**Design Addendum**

For Reselton Properties

This Design Addendum has been prepared in direct response to a series of comments provided by London Borough of Richmond Upon Thames regarding the submitted proposals for the former Stag Brewery site in Mortlake.

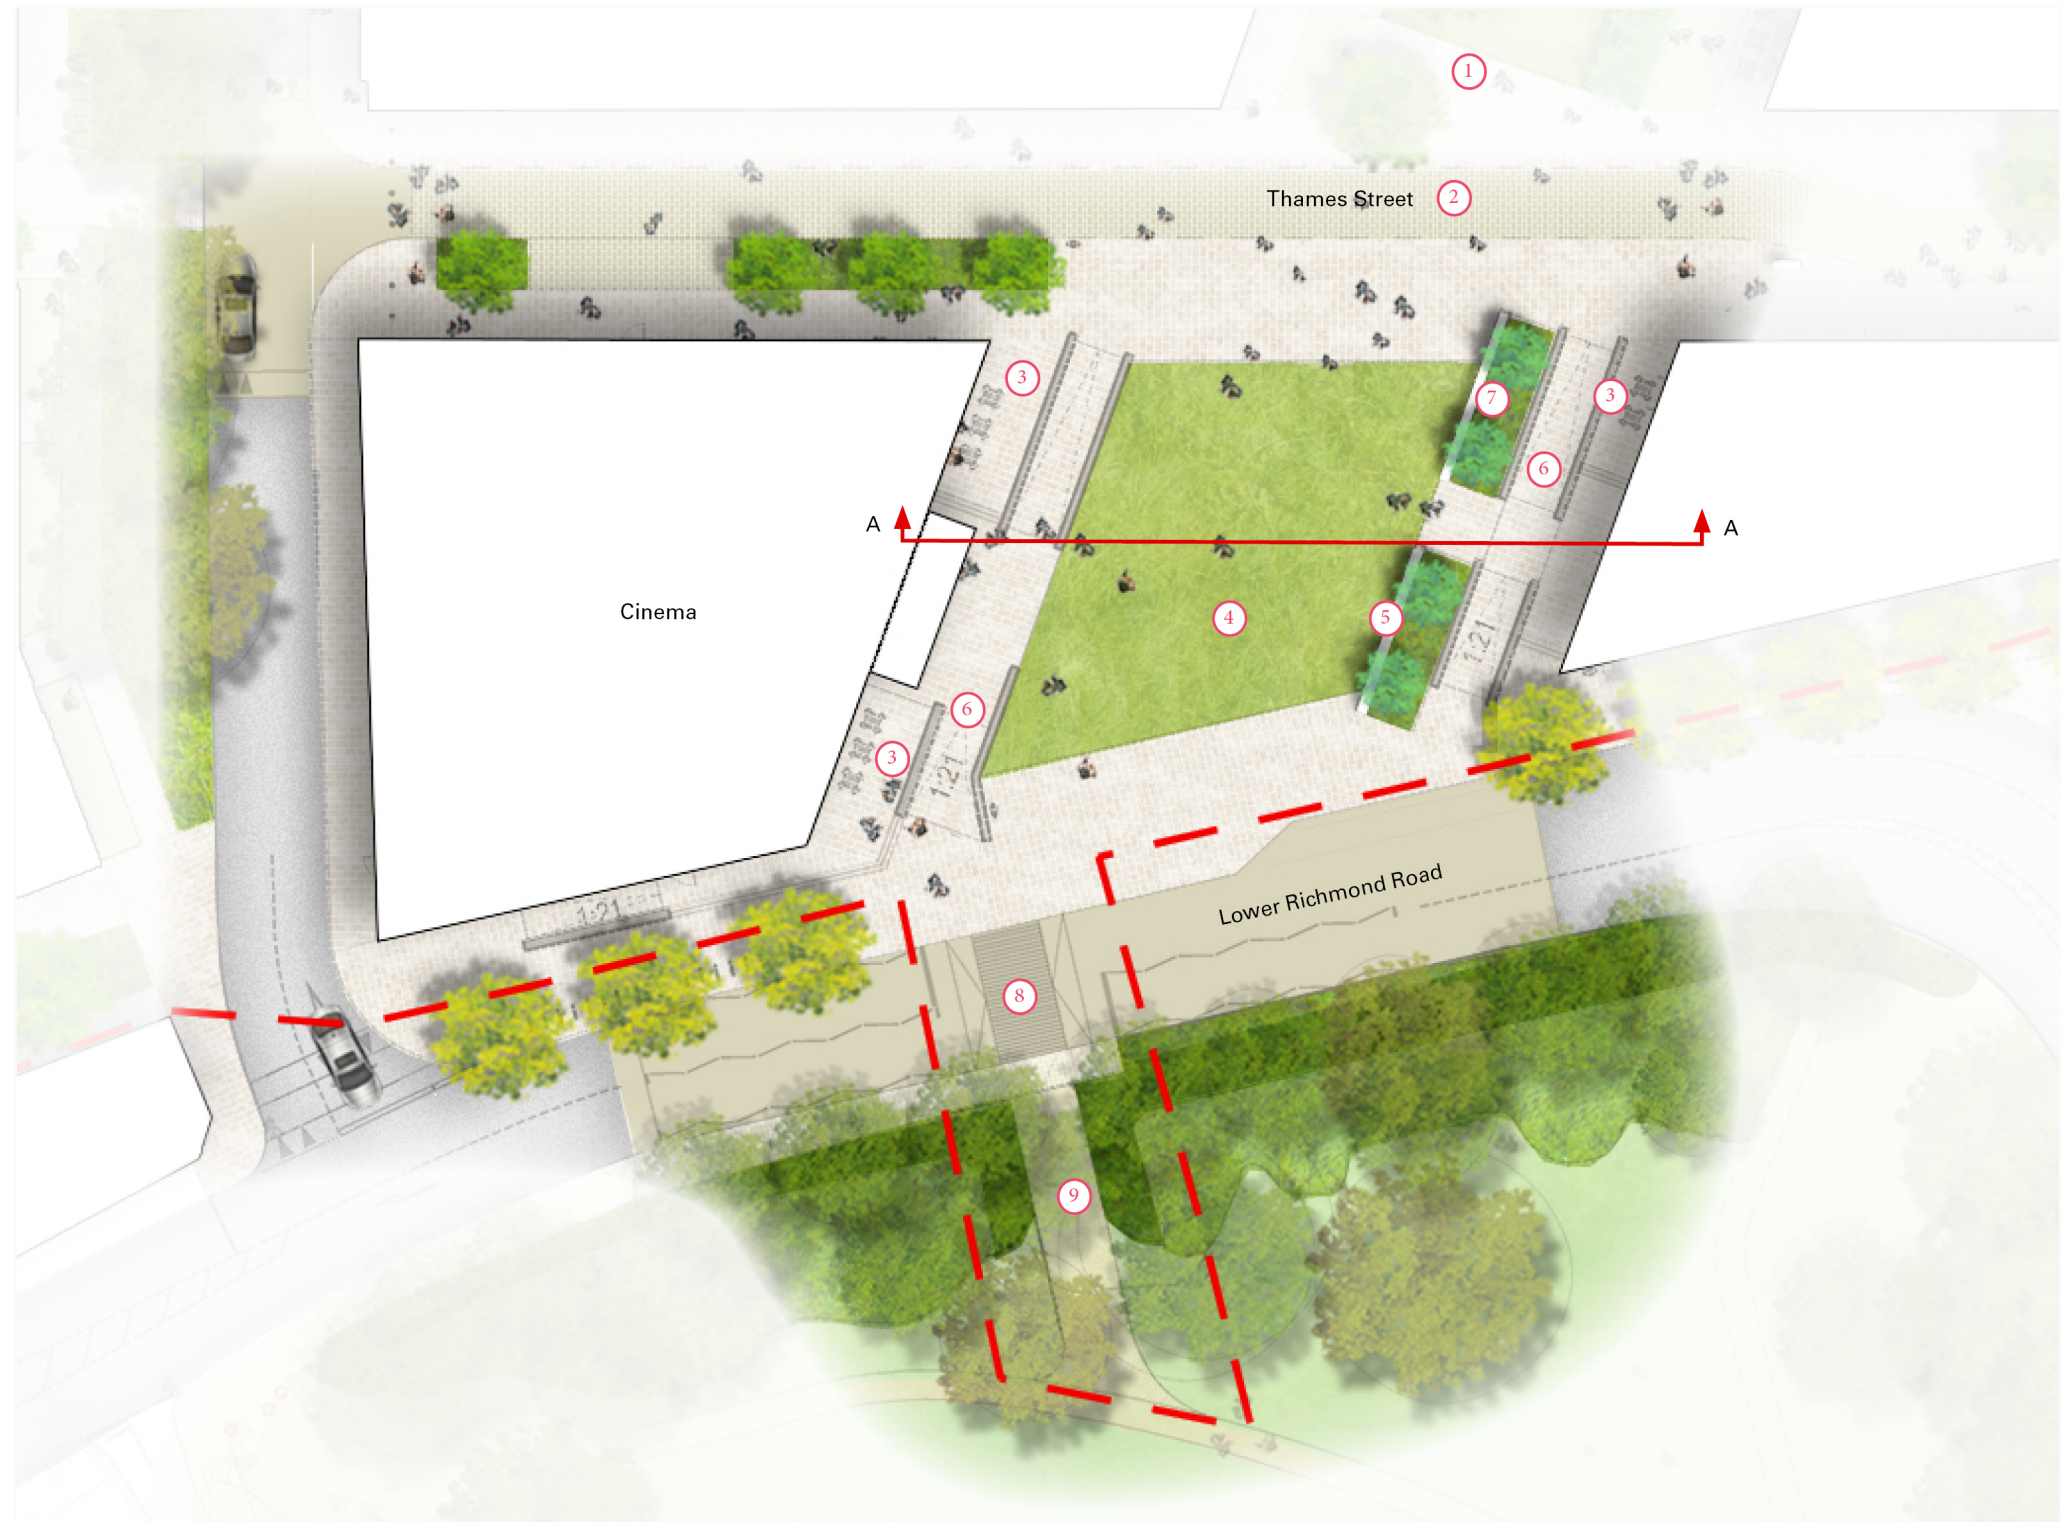
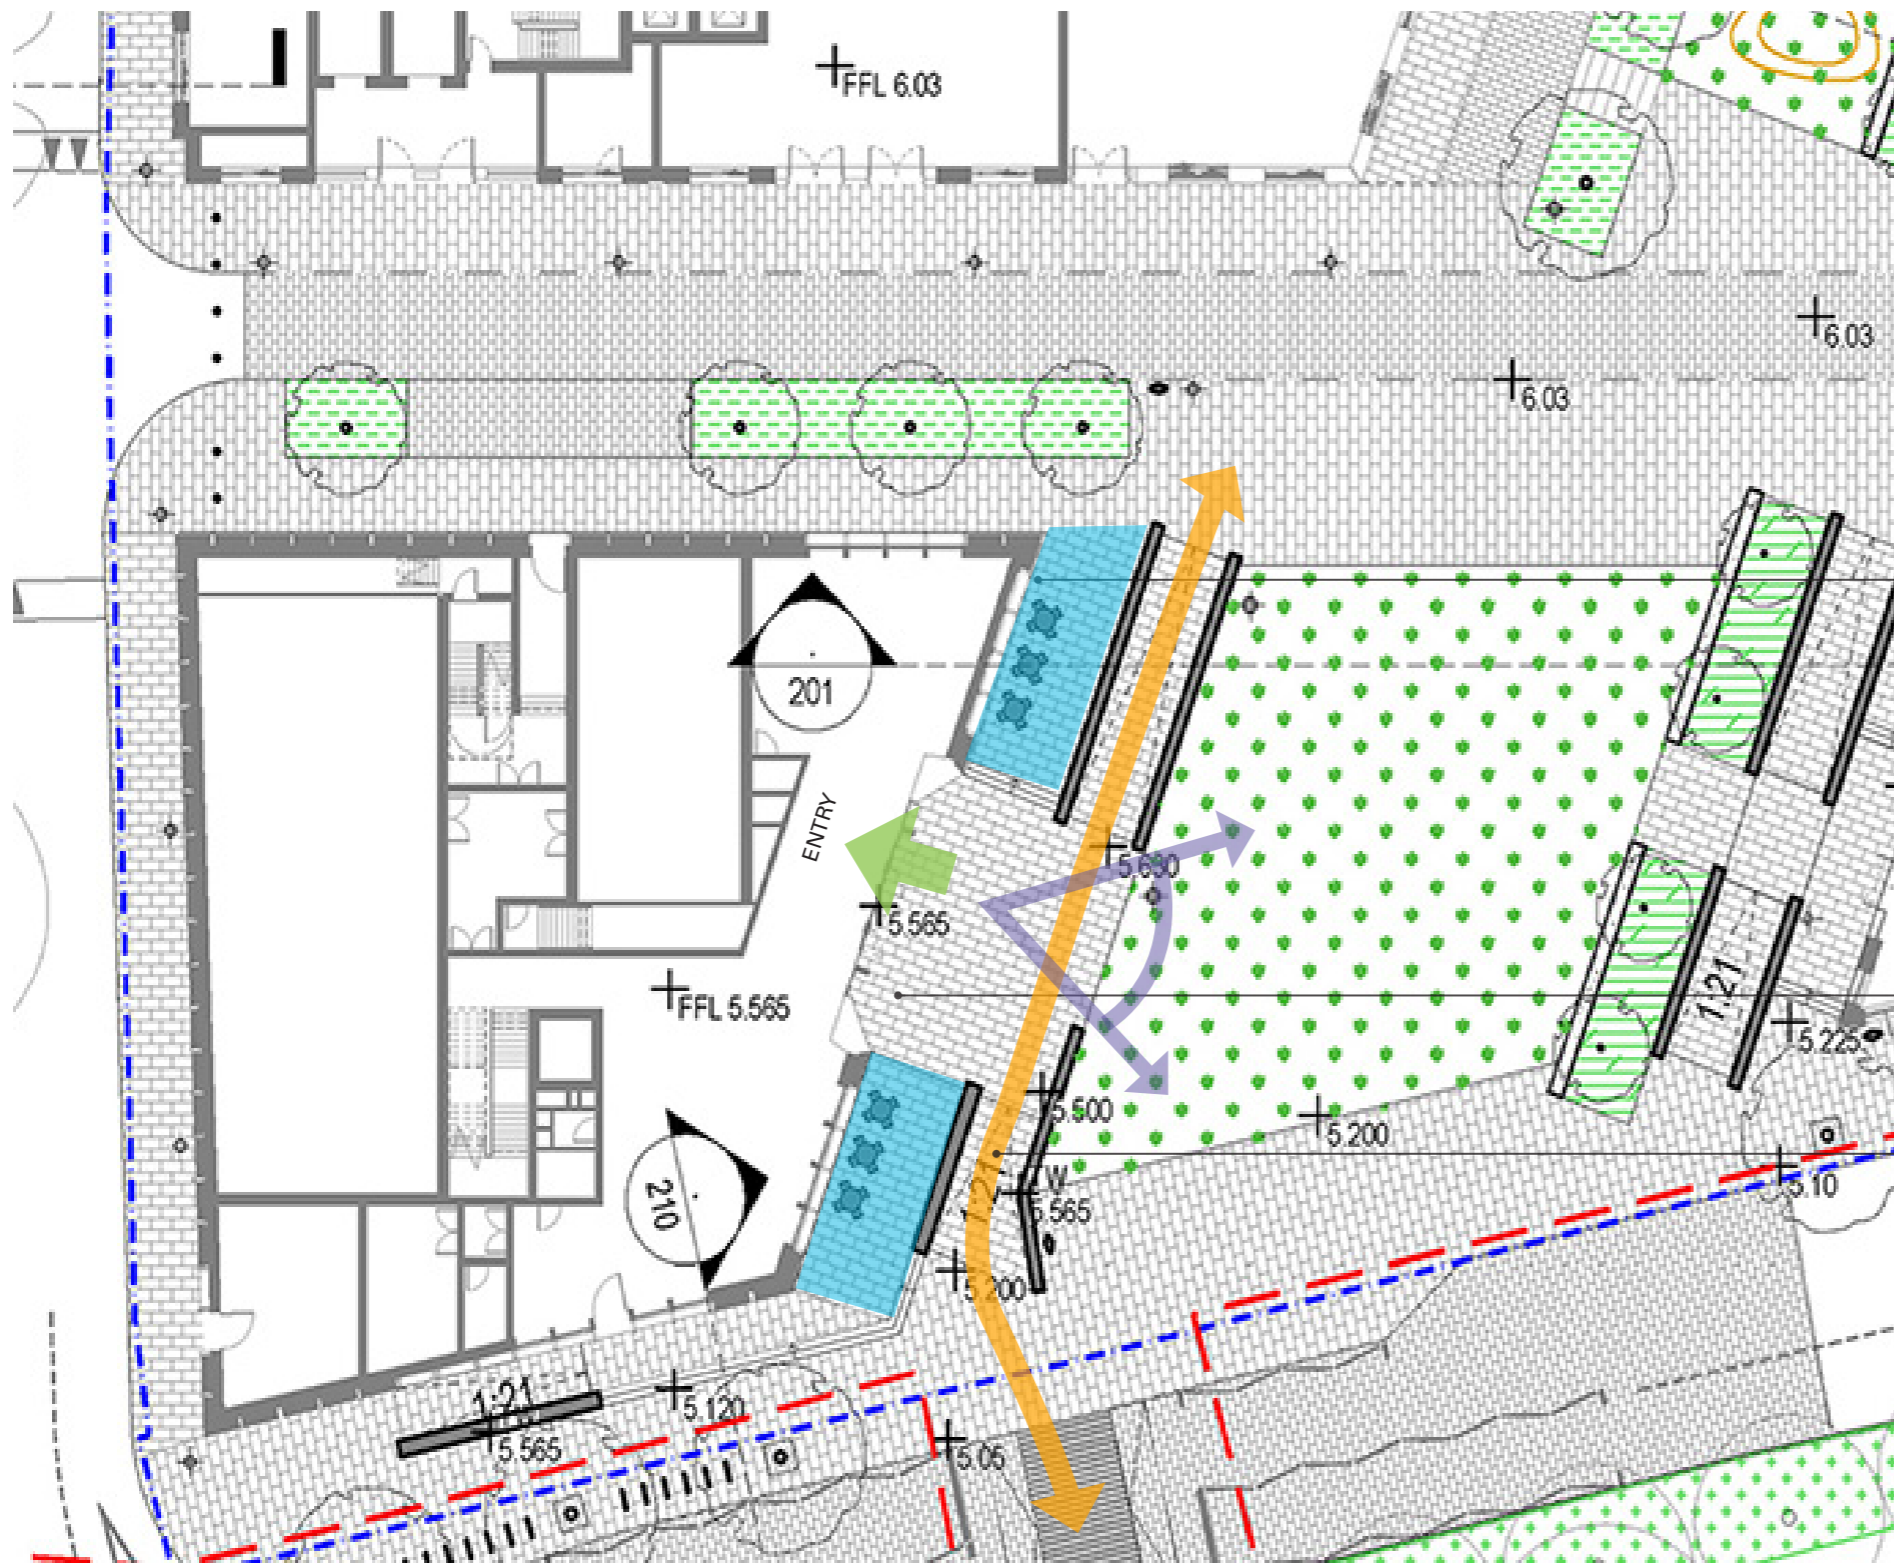
2. Provide direct level access to omit steps and ramps.

The proposed floor level of the Cinema is set mid-way between proposed Thames Street and Lower Richmond Road (LRR) and provides the ground floor of the building with relationships to both streets and to the public open space and, particularly to the circulation route and gathering space of the Green Spine.

Gillespies have designed the access around the building to provide steps and accessible walkways into a central entrance landing facing into the Green Spine. The main access route from LRR and Mortlake Green and beyond is via the graded walkway that runs either side of the Green Link directly through the site to the river. Graded slopes of 1:21 incline and edged with raised kerbs / seating walls provide an accessible route to the main eastern entrance and past the building, linking LRR and Thames St. Outside the cinema, there are level areas that form spill-out terraces, slightly raised above pavement level and overlooking the Green Spine and LRR, providing animation to the streetscape as well as valuable amenity space for the users of the cinema.

A secondary direct entry from LRR is provided with a continuous line of steps wrapping the corner and an accessible graded walkway at the western end down to footpath level. The configuration of these steps and graded walkway is designed to maintain a min public footpath along LRR past the site and

Block 1 (cinema) - Proposed north elevation

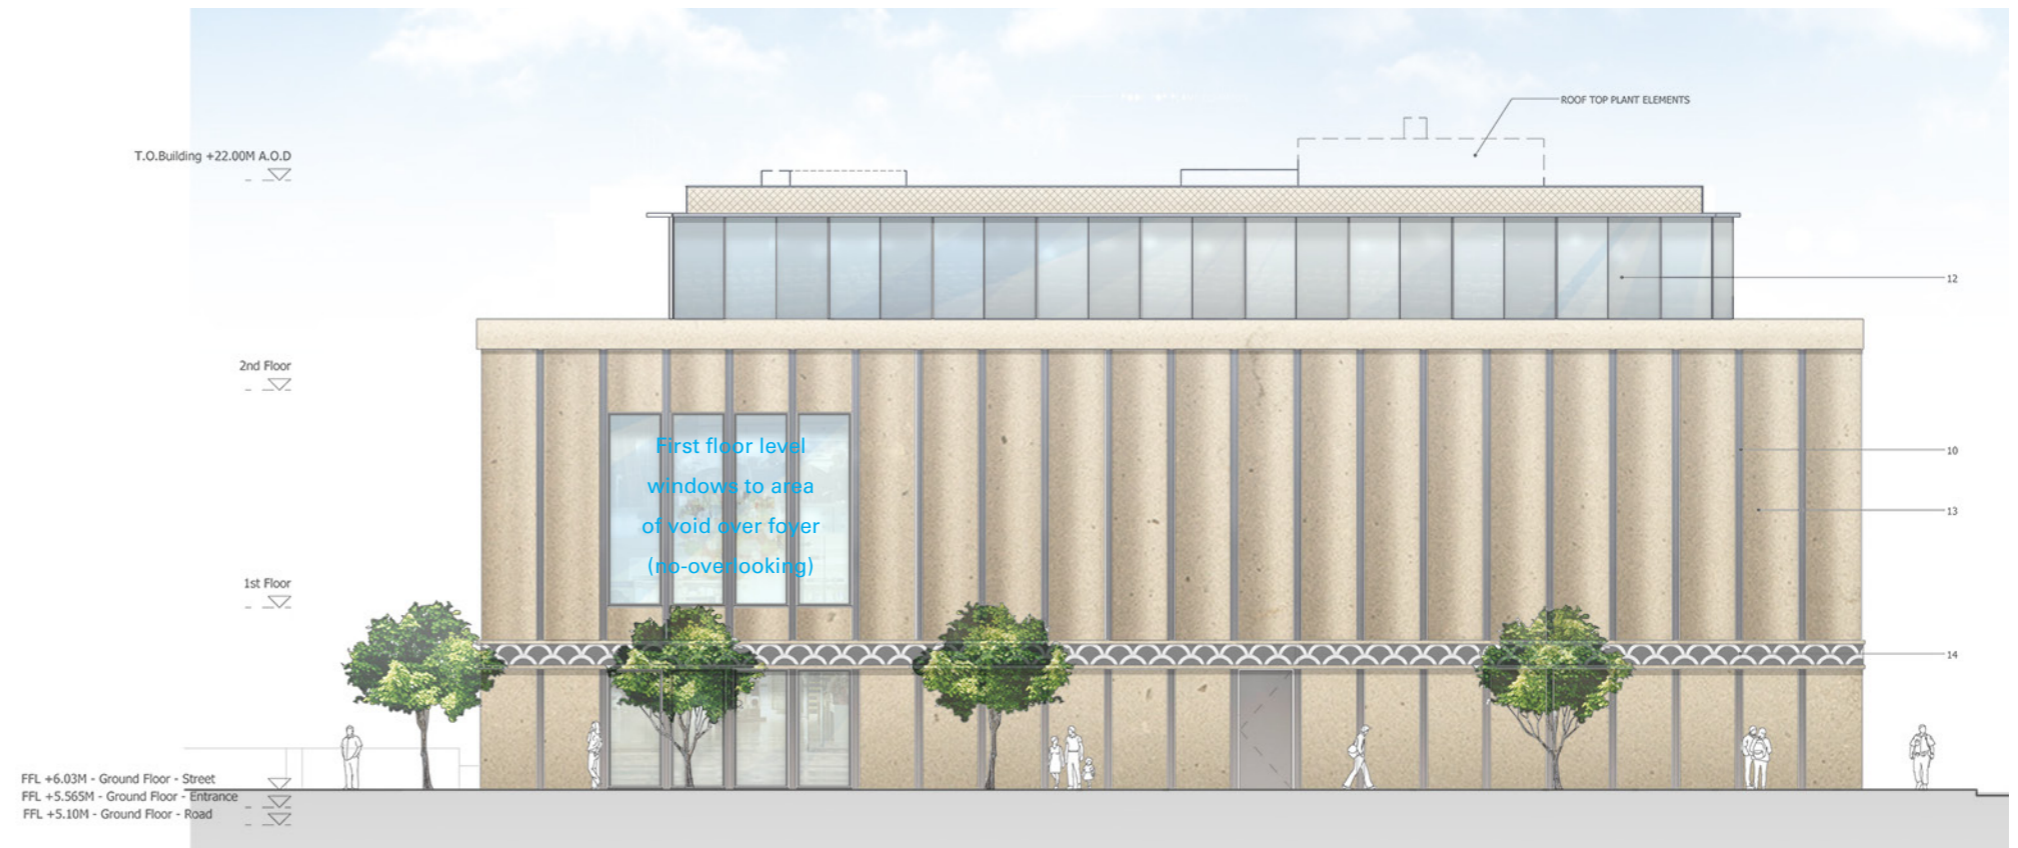
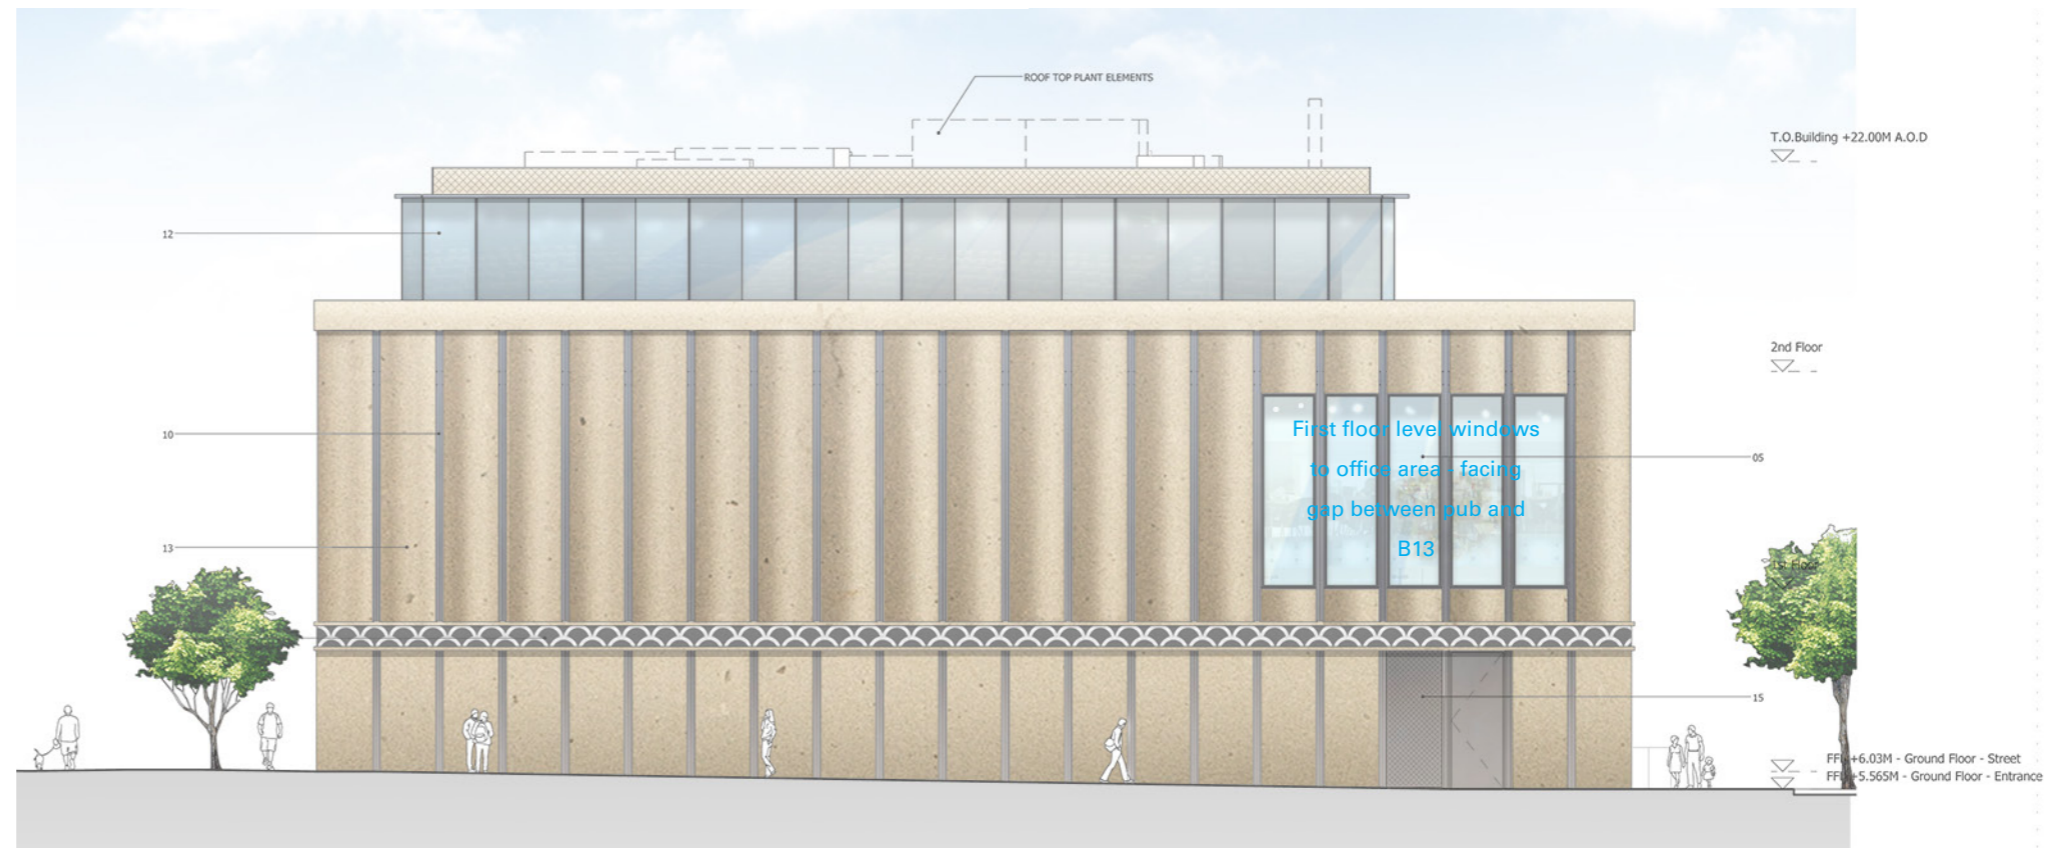
- West and north elevations. The main view for future residents appears to be of 4 storeys of solid pre-cast concrete cladding. This will have adverse effect on the value of the residential units?

The nature of the use of the building as a cinema requires a large proportion of windowless facades. On one hand this means that those parts of the facade are not animated by windows, however that may also be seen as a benefit in terms of the lack of overlooking issues to these areas. The internal configuration of the building has been designed to specifically locate the screens (which require solid facade) to the north and west - this has been to ensure active frontages are provided towards the green link and Lower Richmond Road. The elevation treatment has been carefully considered to provide strong character and relief. The fluted concrete piers will cast light and shadow in a manner reminiscent of a cinema curtain - not dissimilar to the effect of the award winning Centre for Contemporary Arts in Nottingham (by Caruso St John Architects). By evening this fluted profile provides opportunity for subtle lighting to be incorporated in a manner that avoids light spilling towards its neighbours. We believe this is a suitably elegant approach to the challenge of providing solidity and animation at the same time.
